RE: Ocean Gateway Garage, India and Fore Street, Curbing and sidewalk improvements  
(Id#2005-0271)(CBL 019 A 001001)

On October 28, 2009, the Portland Planning Authority approved the amended site plan for India and Fore Street curbing and sidewalk improvements associated with the Ocean Gateway Garage as shown on the approved plan dated October 1, 2009.

**Philip DiPierro - Re: Ocean Gateway Garage**

AMENDMENT TO  
LONGFELLOW RESIDENCE AND RETAIL PROJECT  
VICINITY OF  
INDIA STREET AND FORE STREET  
SITE PLAN AND SUBDIVISION REVIEW  
RIVERWALK, LLC., APPLICANT

**SITE PLAN**  
SCALE: 1"=20'

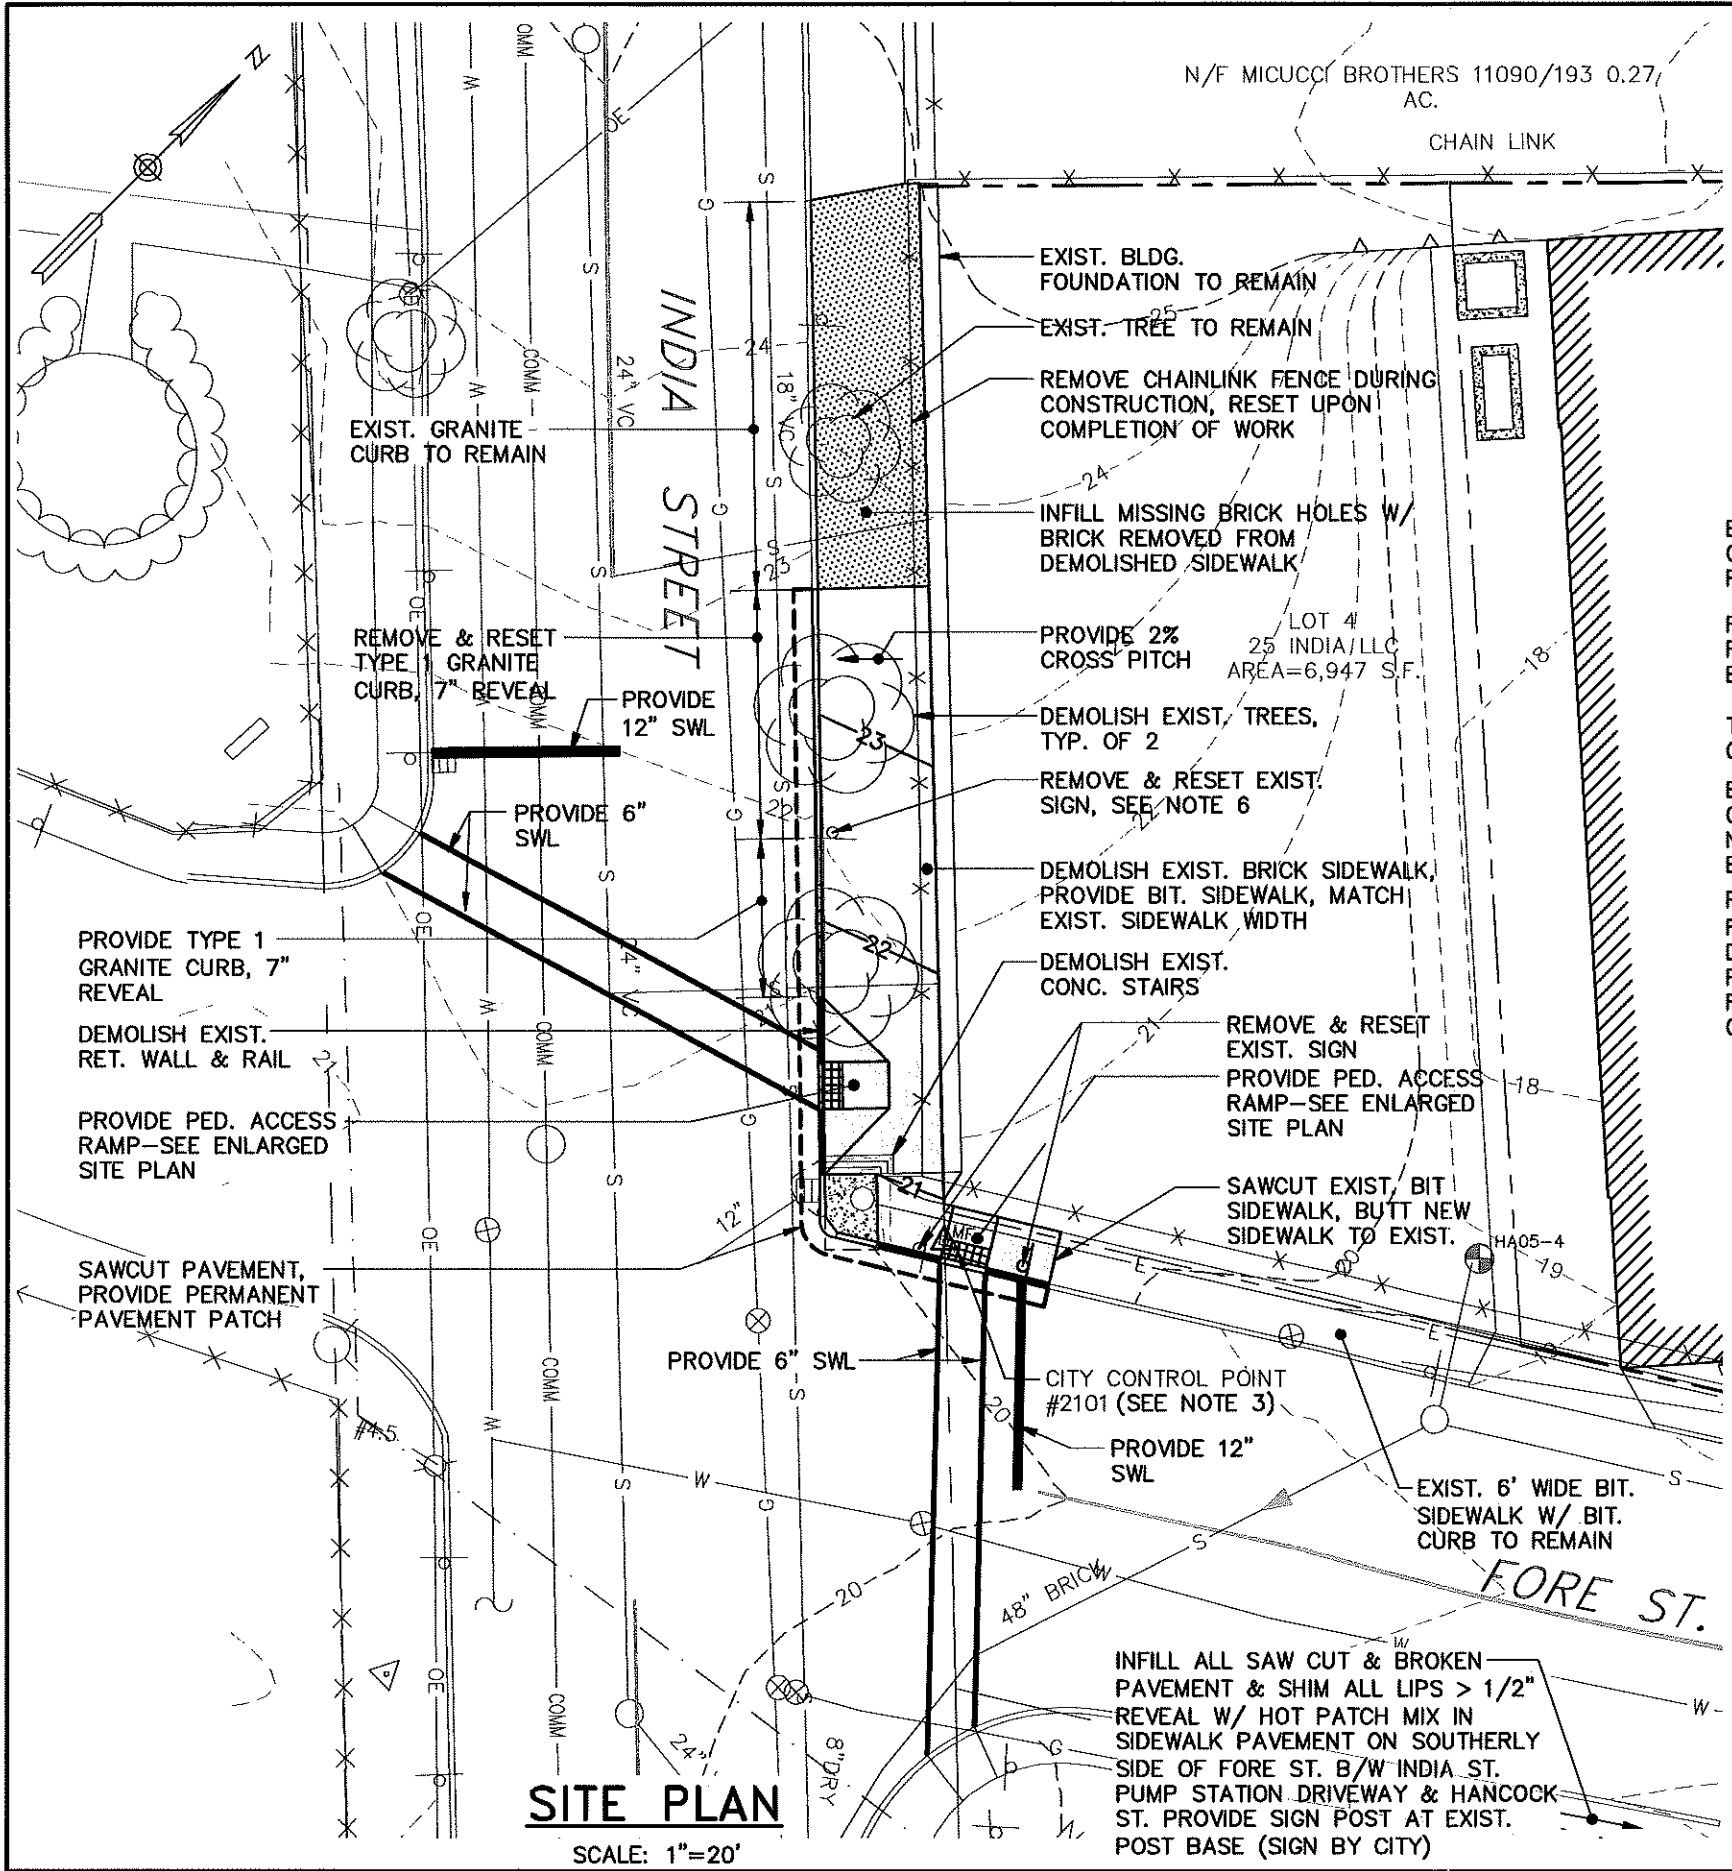
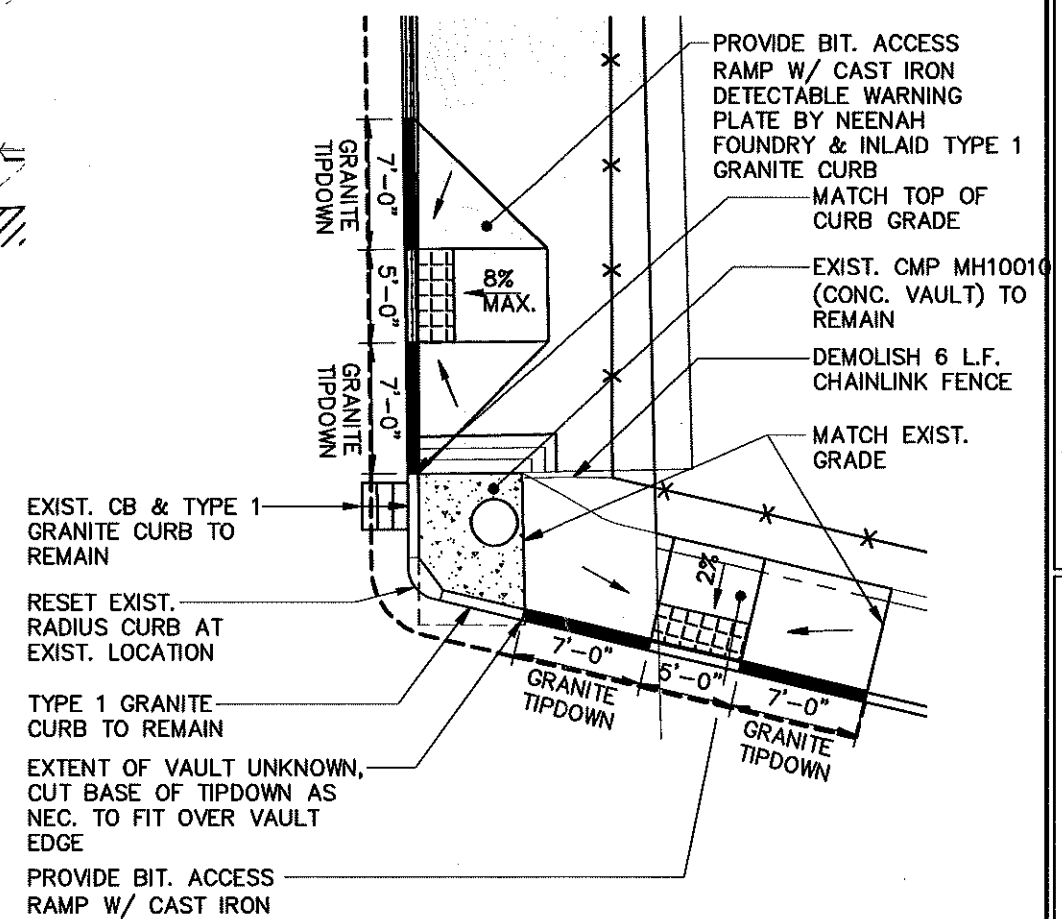
3. ~~Sidewalk materials~~ The site layout plans show bituminous pavement on the sidewalks in front of the India Street office building site. These features should be noted as temporary, to be replaced with brick upon completion of the office building.

- NOTES:
1. BIT. SIDEWALK AND PEDESTRIAN ACCESS RAMPS ALONG FORE ST. AND INDIA ST. ARE TEMPORARY. BRICK SIDEWALK AND RAMPS, AS PER CITY APPROVED SITE PLAN, SHALL BE PROVIDED IN FUTURE PHASES OF WORK.
  2. PEDESTRIAN ACCESS RAMPS SHALL CONFORM TO ADA STANDARDS. WORK SHALL CONFORM TO PROJECT DETAILS AND CITY OF PORTLAND TECHNICAL AND DESIGN STANDARDS AND GUIDELINES.
  3. CUT EXIST. GRANITE MONUMENT AS NEC., PROVIDE COPPER ROD & CITY SURVEY WASHER MARKED TO CITY OF PORTLAND STANDARDS BY PROF. LAND SURVEYOR, RESET FRAME & COVER TO PROPOSED GRADE.
  4. LOCATION OF STOP BARS AND SIGN RELOCATION SHALL BE APPROVED BY CITY IN ADVANCE OF WORK.
  5. ALL CONFLICTING PAVEMENT MARKINGS SHALL BE REMOVED BY SURFACE GRINDING.
  6. PARKING SIGNS SHALL BE MODIFIED AS NEEDED FOLLOWING COORDINATION WITH THE CITY.

FIG. 1  
Horizontal Illuminance measured in footcandles at grade

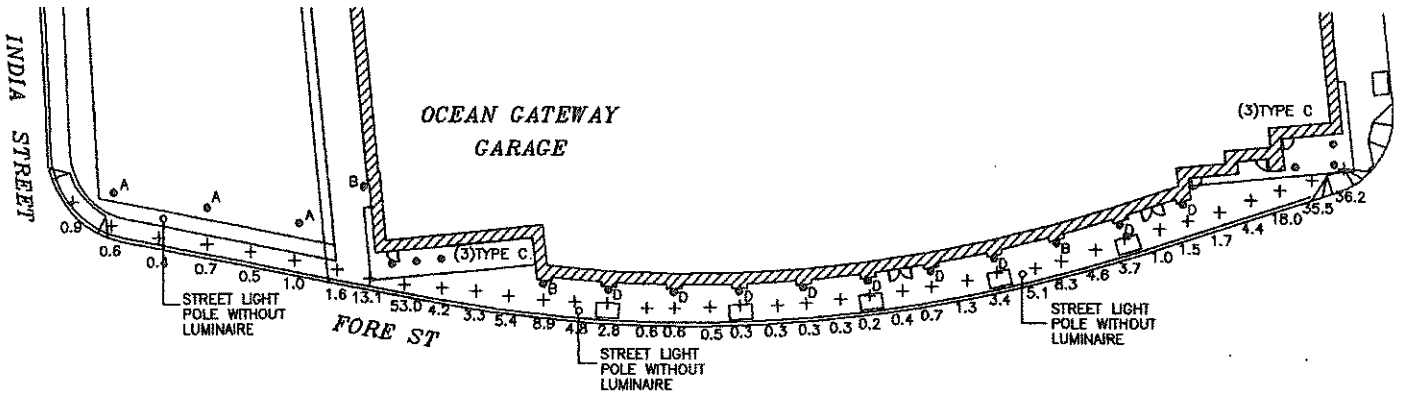
I measured illuminance levels at grade along the parking garage sidewalk center line at Fore Street from Hancock Street extension to India Street. The results of these measurements are noted in the plan shown in Figure 1 below. The section of the sidewalk between the India Street side of the garage and the India Street sidewalk was measured to have an average illuminance of 0.8 footcandles. The section of the sidewalk immediately in front of the curved garage wall, between the two corners of the building that have canopies was measured to have an average illuminance of 2.4 footcandles. This section of sidewalk includes the two temporary 175 watt metal halide wall lights. The minimum illuminance level measured was 0.2 footcandles.
